24 February 2011

**Moolarben Coal Complex Stage 2 \_ Preferred Project Report 08\_135**

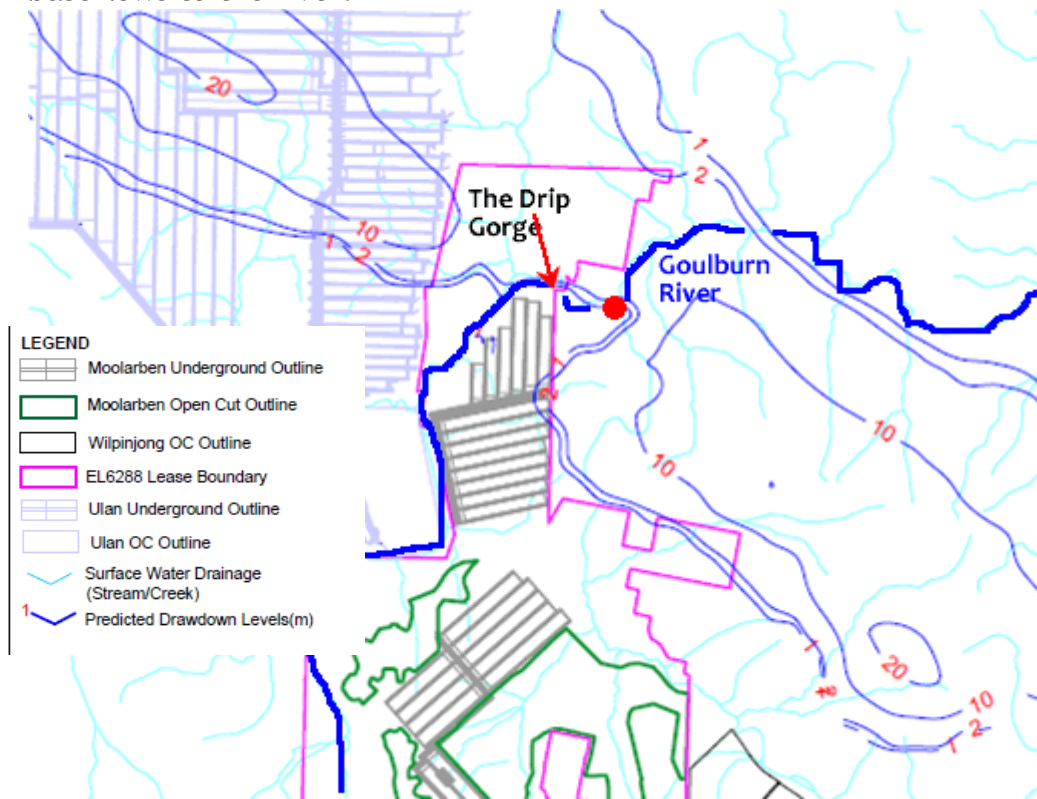
Based on available water sources MCC is predicted to have a water deficit of 23 years out of 24 with a peak demand of 3852ML/year. MCC revised maximum water demand for dust suppression of 2.2ML/day (783ML/year) is an extrapolation of the 1.1ML/day used in 2010 (Stage 1) for washing 4MT/yr. If opencut coal production is increased to 13MT/year (ie 3 x 2010 levels) 2.2ML/day for dust suppression appears inadequate. It is also inconsistent with UCMLs requirements for dust suppression of 1978ML/year (based on 2007/2008 UCML 2009 App. 7 Fig 2.1). This highlights the need for a closer scrutiny of the overall water demand considering the immense cumulative mining disturbance footprint, the critical need to suppress dust pollution and the considerable volume of water involved.

Fig 2.5 - MCC Transect 4 - with Drip seepage zone height corrected to 8-12m  
PZ129 superimposed (depth to scale - from LOG)

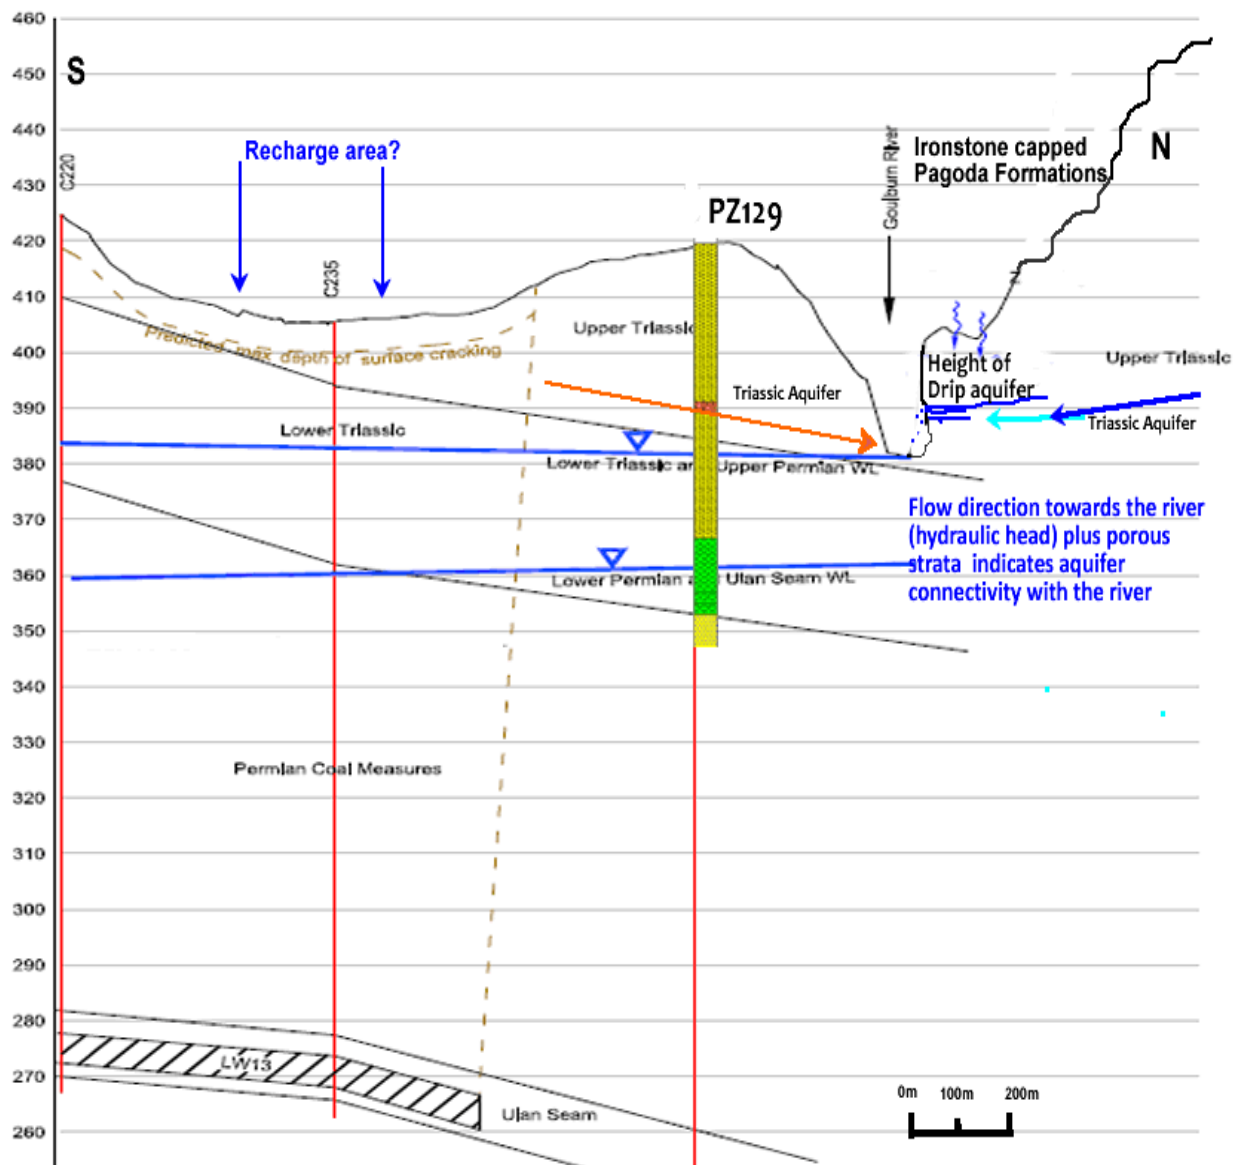
Increased vertical hydraulic permeability due to mine subsidence occurred above UCML underground prior to 2006 and the installation of the wider long wall faces. Table 5.9 (p.48 MCP GIA) shows increasing mine inflows from the 1990s, accelerating in 2000-2002 wet years (from 5.6- 7.7 ML/day). Triassic Bore PZ129 has a hydraulic head range 390-393mAHD (MCC AEMR 2010-11) this is above the level of the river (~382m AHD) indicating groundwater flows towards the River (see Fig2.5).

The GDE referred to as ‘The Drip’ has not been adequately investigated or understood. Local knowledge will confirm that seepage is sustained throughout the severest of droughts; this resilience suggests it is fed by a permanent groundwater source located above the ‘dripping’ discharge area (~ 390 mAHD - halfway up the cliff face). While the aquifer would obviously rely on replenishment from rainfall events, it may also be sustained from upward pressure from joint or fault connecting it to the Triassic aquifer system (Pz129 = 389-392 mAHD) and therefore could be potentially drained if the Triassic Aquifer was depressurised. The water level in hydraulic head of Triassic Bore PZ 129c (opposite The Drip) indicates groundwater flow towards the river.
